LIGHT RAIL PERMITTING ADVISORY COMMITTEE

COMMITTEE MEETING

Dec. 3, 2014 | 3:00PM - 5:00PM | ROOM 1E-113

South Bellevue Pre-Development Advisory Document

SOUTH BELLEVUE STATION - PERSPECTIVE GARAGE SOUTH ENTRY

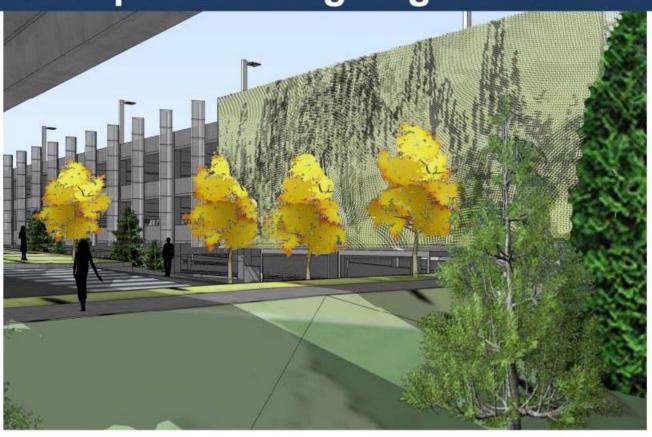
- The CAC has a strong desire to see the use of a living wall designed into the South Bellevue Station Garage.
- The CAC would like Sound Transit to evaluate a living roof or roof deck planters as an additional way to relate the parking garage to the natural environment of Mercer Slough.

- The CAC would like to see a design of the South Bellevue Station and Garage that more visually relates to a park concept.
- The CAC would like to see green wall screening as an approach to soften some of the hard edges of the South Bellevue Station Garage. This would not necessary be a living wall but a landscape feature that achieves the same goal.

- The CAC would like Sound Transit to evaluate the possibility of using an artistic design for the mesh screening at the South Bellevue Station Garage.
